ADDENDUM NO. 2

Reference: Woodbury Business Building Remodel
Utah Valley University – Orem, Utah
DFCM Project No. 09171790

ADDENDUM #02 to the “Construction Documents”

Addendum #02

B2 ENLARGED PLAN
AE4-01 SCALE: 1/4"=1'-0"

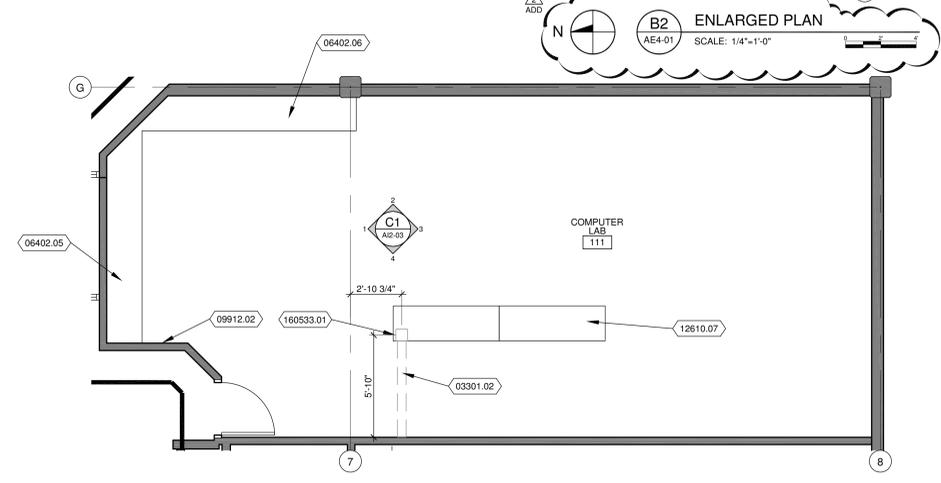
- 02.05 **SHEET COVER**
Change: AV Equipment sheets TA-01, TA5-01, and TA6-01 have been noted as “FOR REFERENCE ONLY”.
- 02.06 **SHEET AE4-01 Enlarged Plan “B2”**
Removed: The Call out and note for the Custom Stainless Steel Bench. These custom stainless steel benches were removed from the scope.

DETAILS
 SCALE: AS NOTED
 SHEET: AE5-11

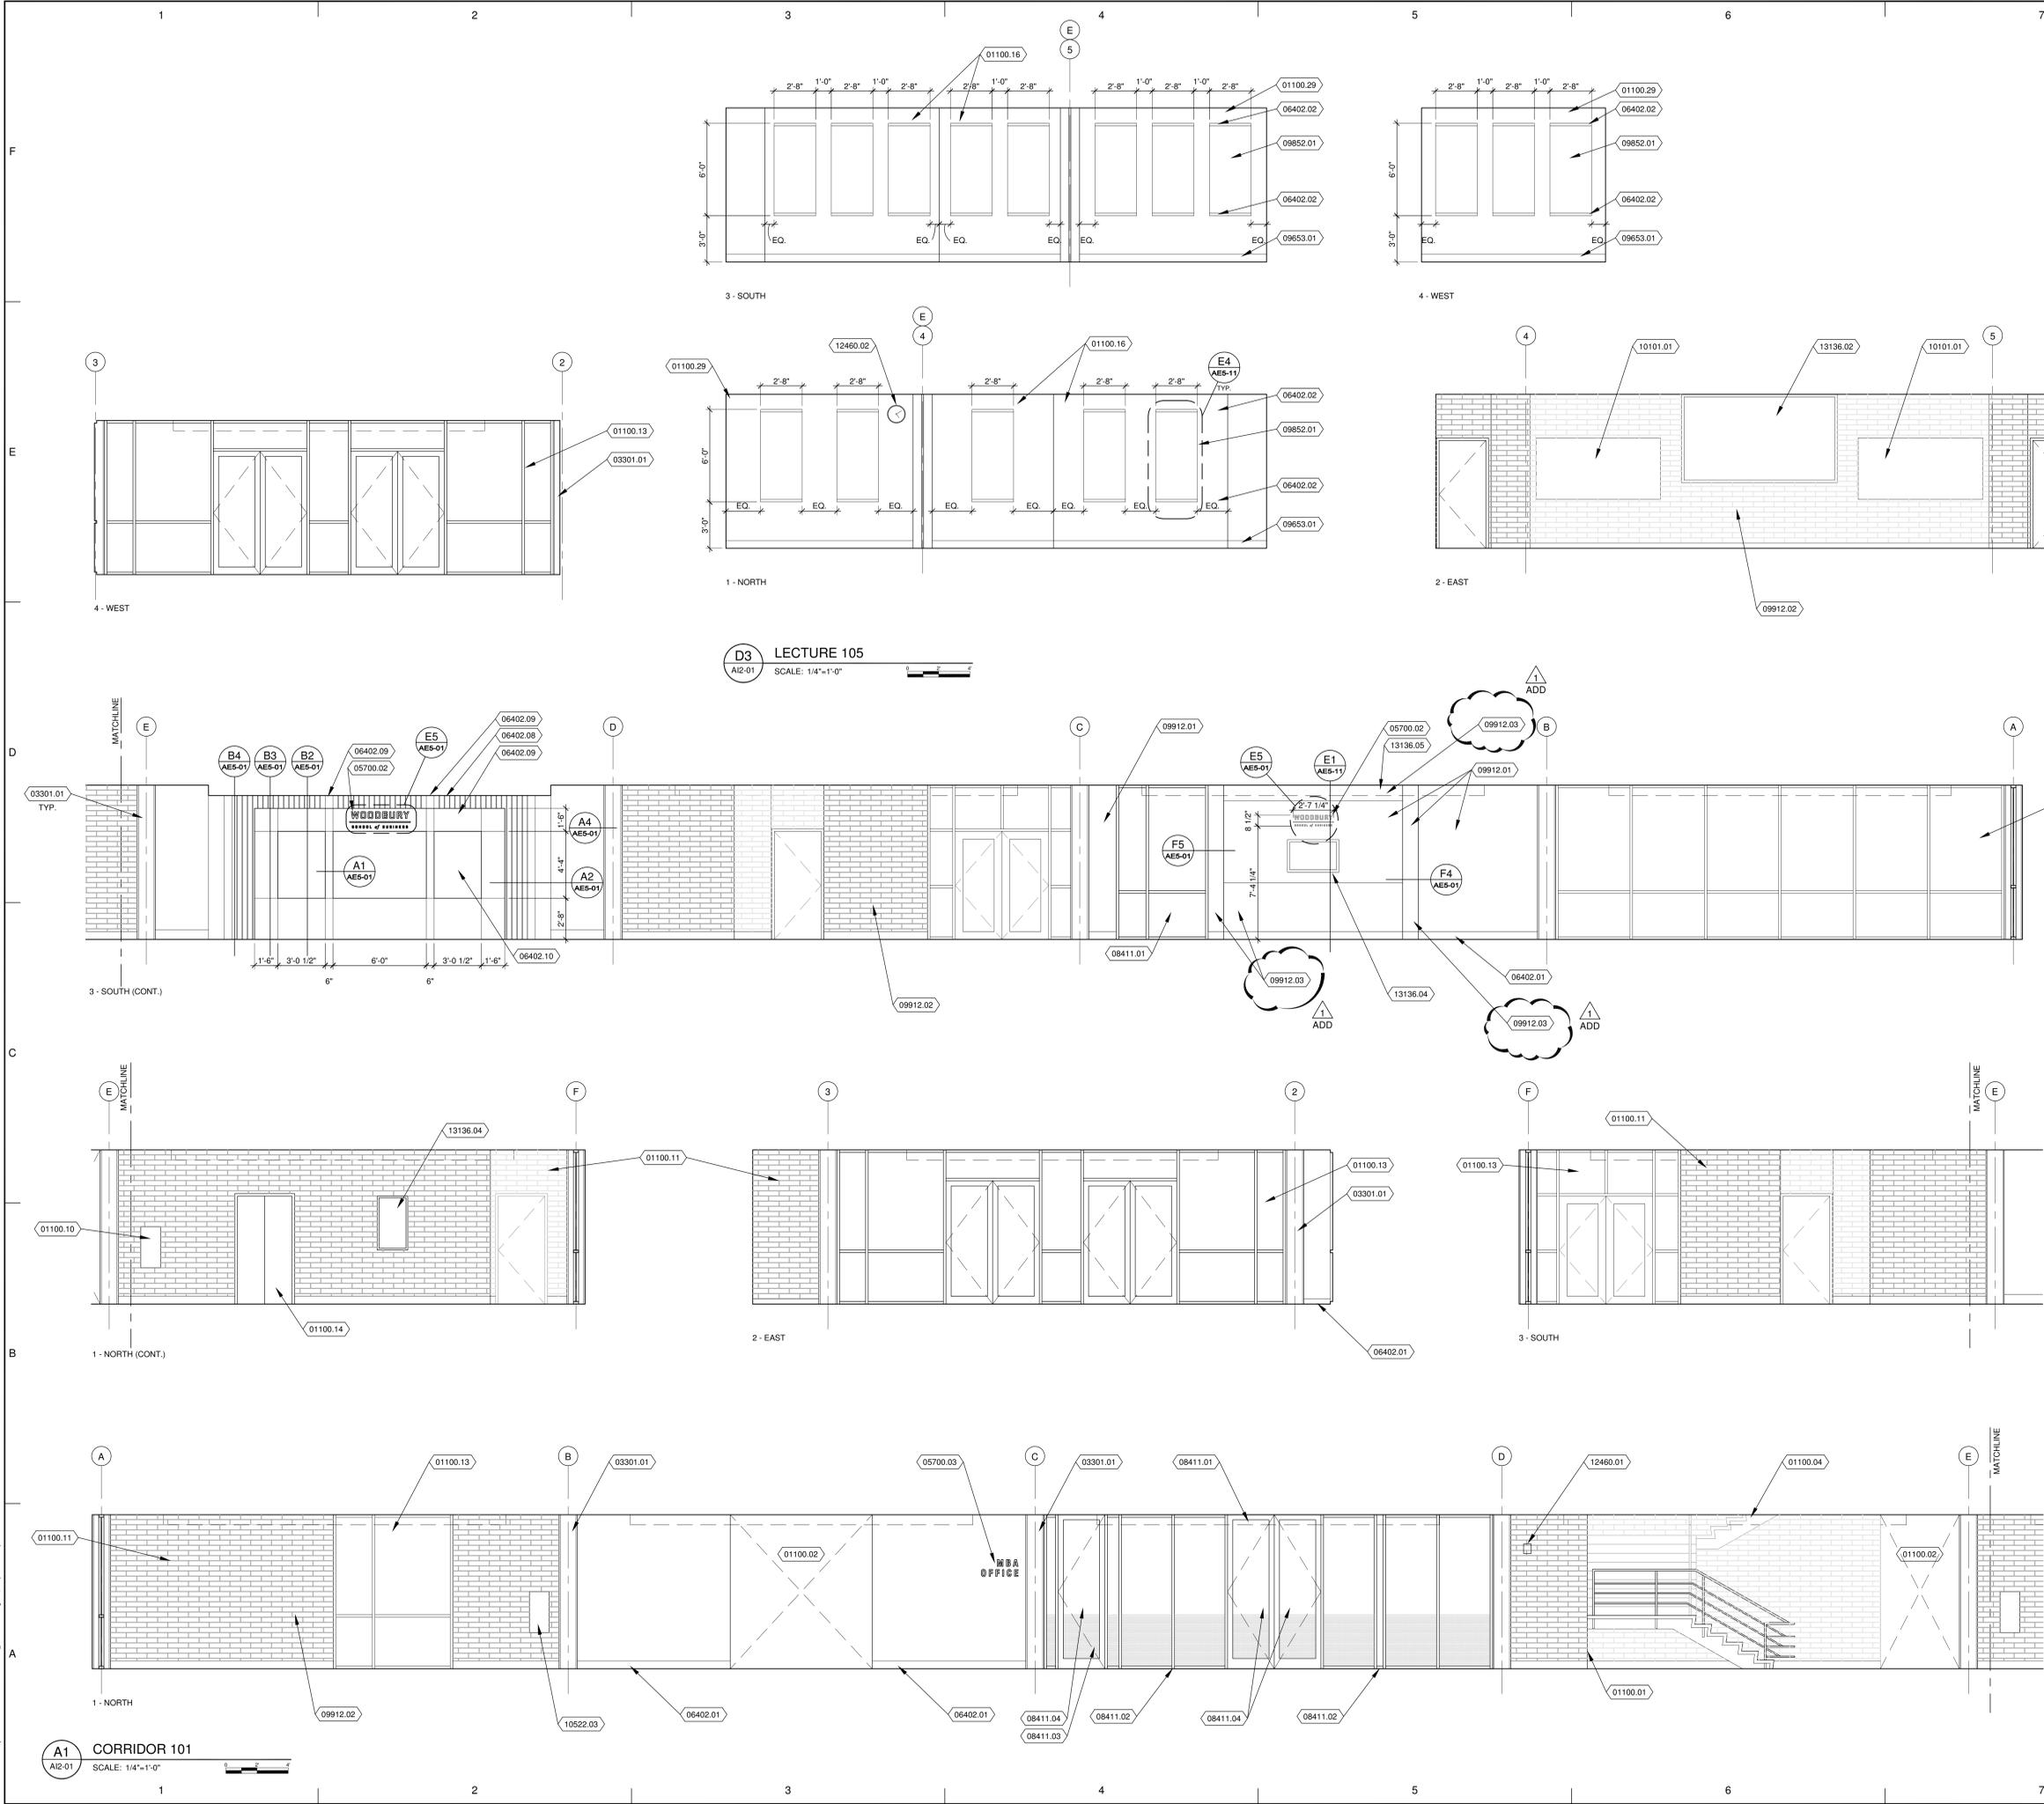
- 02.01 **Change:** The date of Substantial Completion to Wednesday, August 18, 2010.
- 02.02 **Prior Approval Request:** Add Aquatherm Pipe to List of Manufacturers.
Response: Aquatherm Pipe will not be added to the list of manufacturers. There is no domestic water, heating or cooling water piping required for this project. The only piping required for this project is fire protection piping and the Aquatherm piping is not acceptable for fire sprinkler piping systems.
- 02.03 **Clarification:** AV equipment purchase and install is not to be included in the bid, see general note #19 on sheet AG0-01. Notes pertaining to AV equipment on architectural sheets AE5-11, AI2-01, AI2-02, and AR5-01 have been modified to clarify this scope.

PROJECT NO.: 09031
 DATE: 2/16/10
 SHEET: A12-01

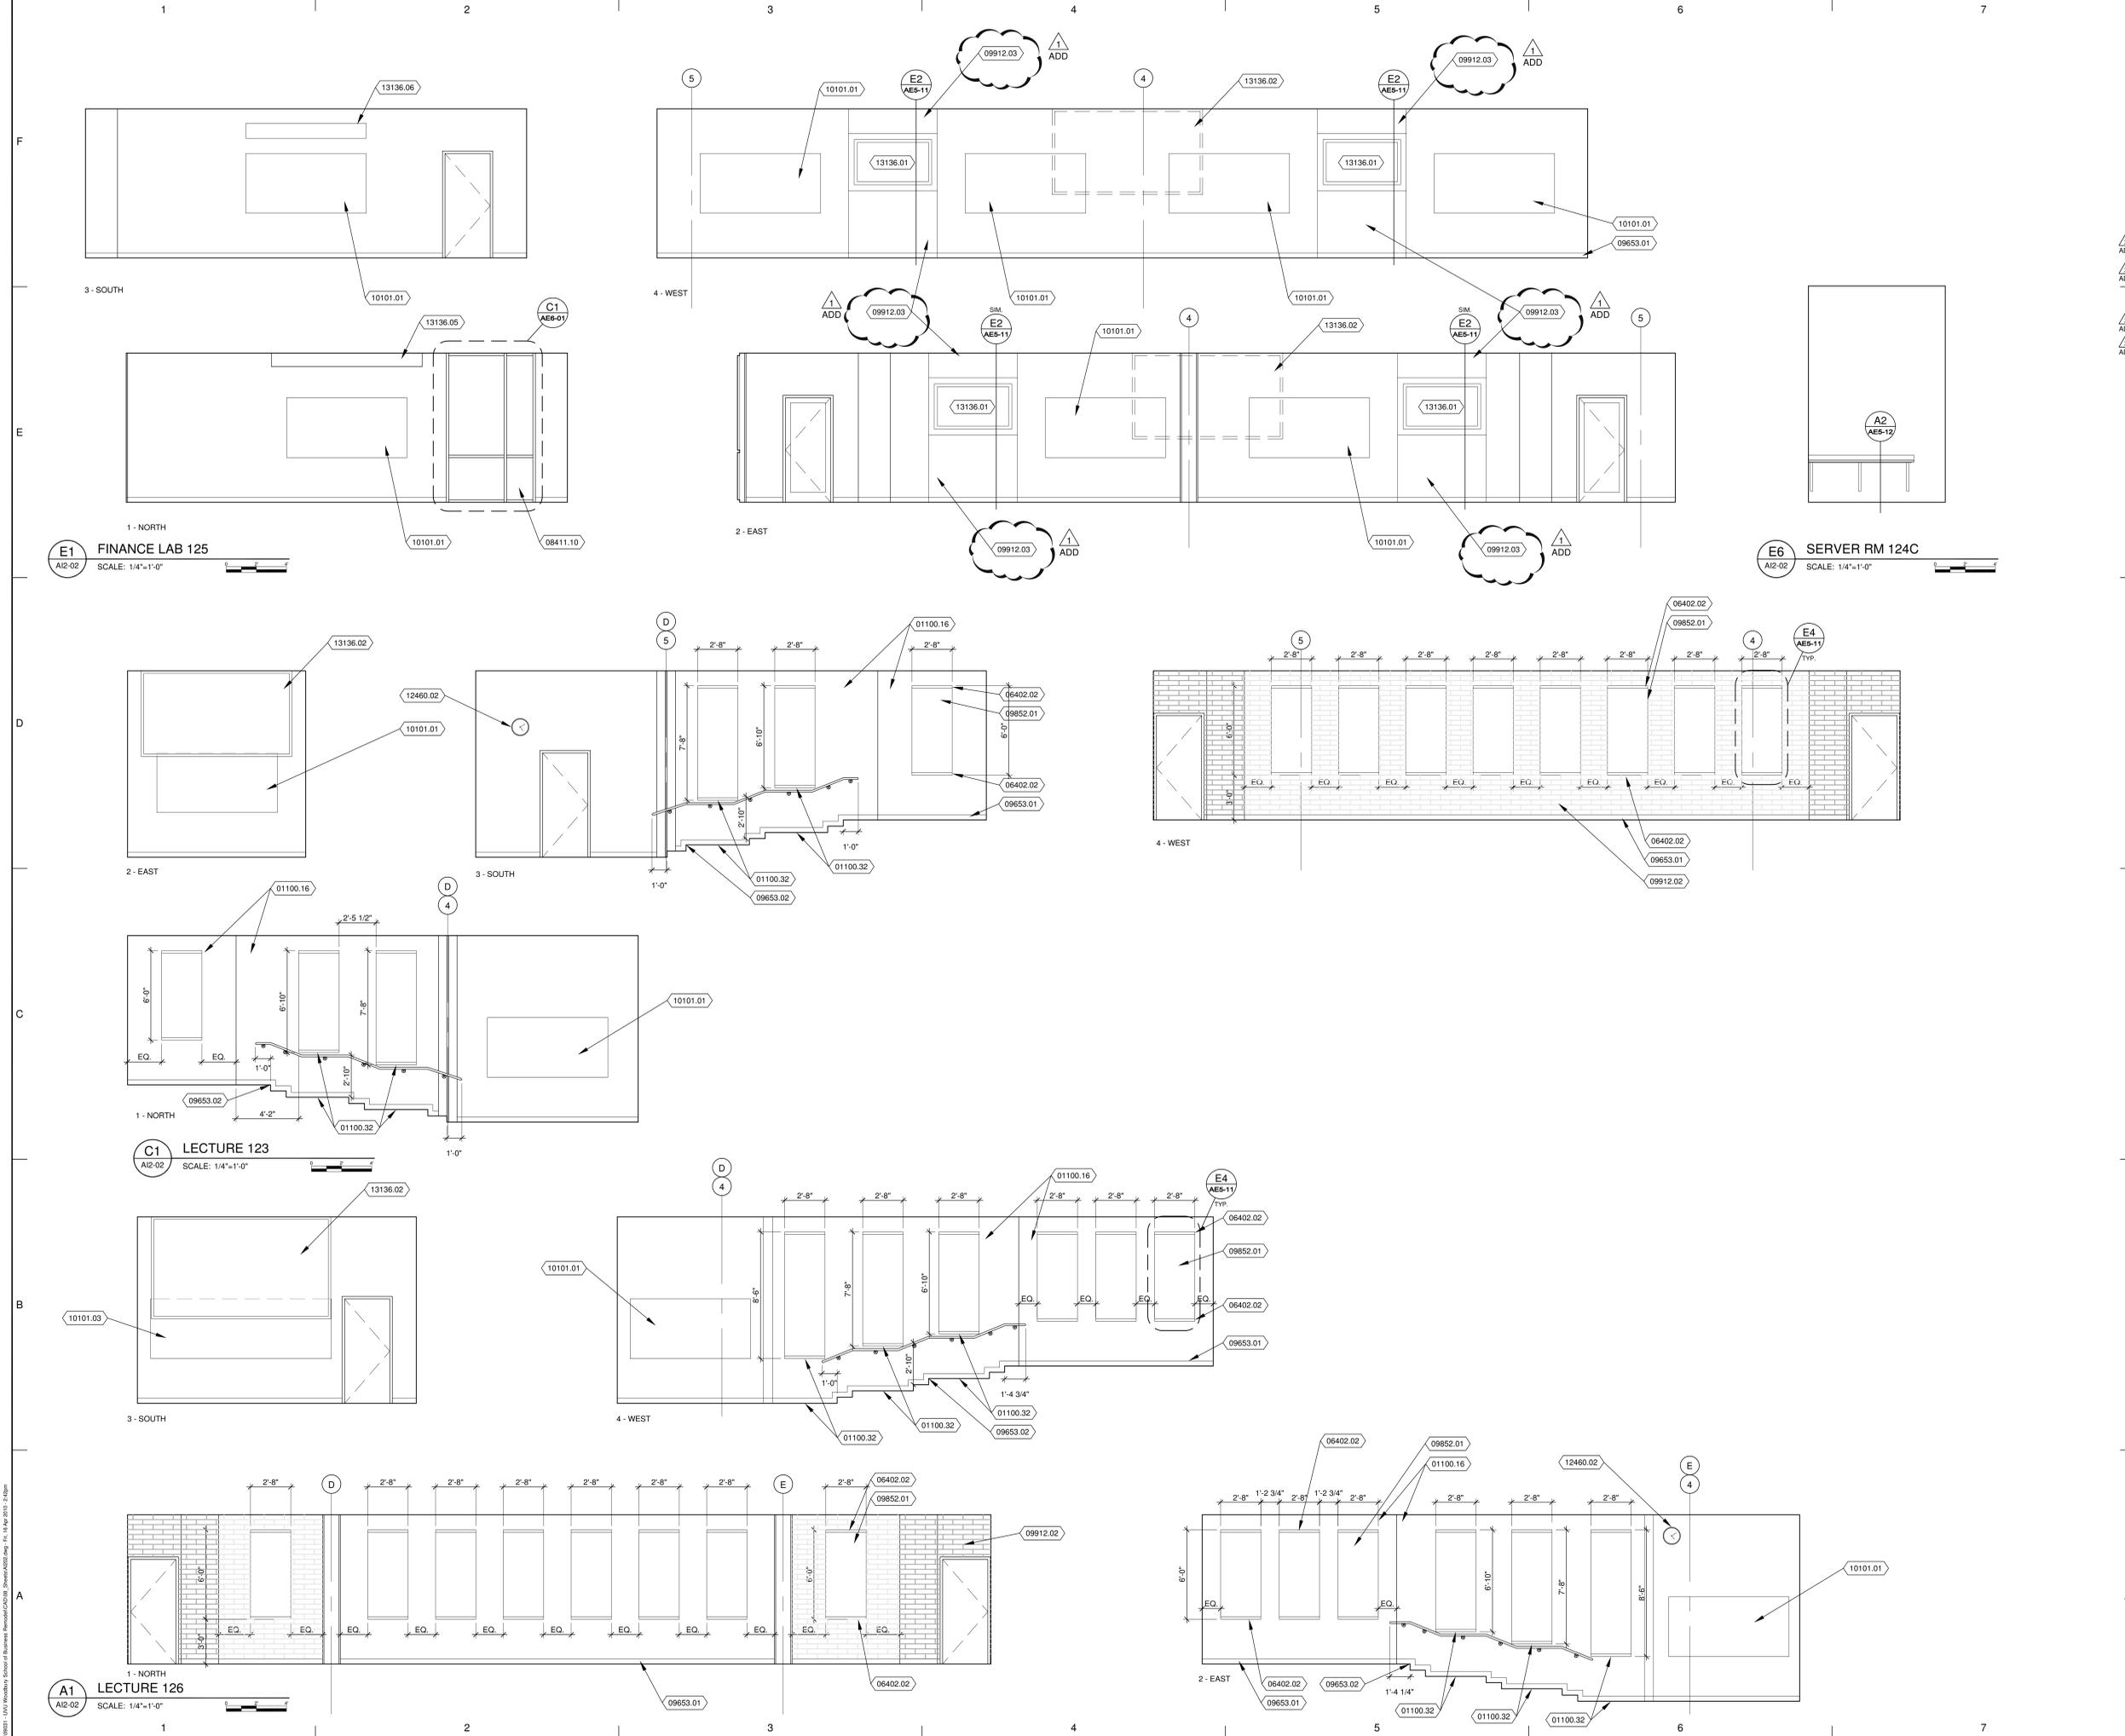
02.07 **SHEETS AI2-01, AI2-02, AI2-03**

Change: Notes pertaining to “Primex” clocks modified to clarify electrical/battery requirements.
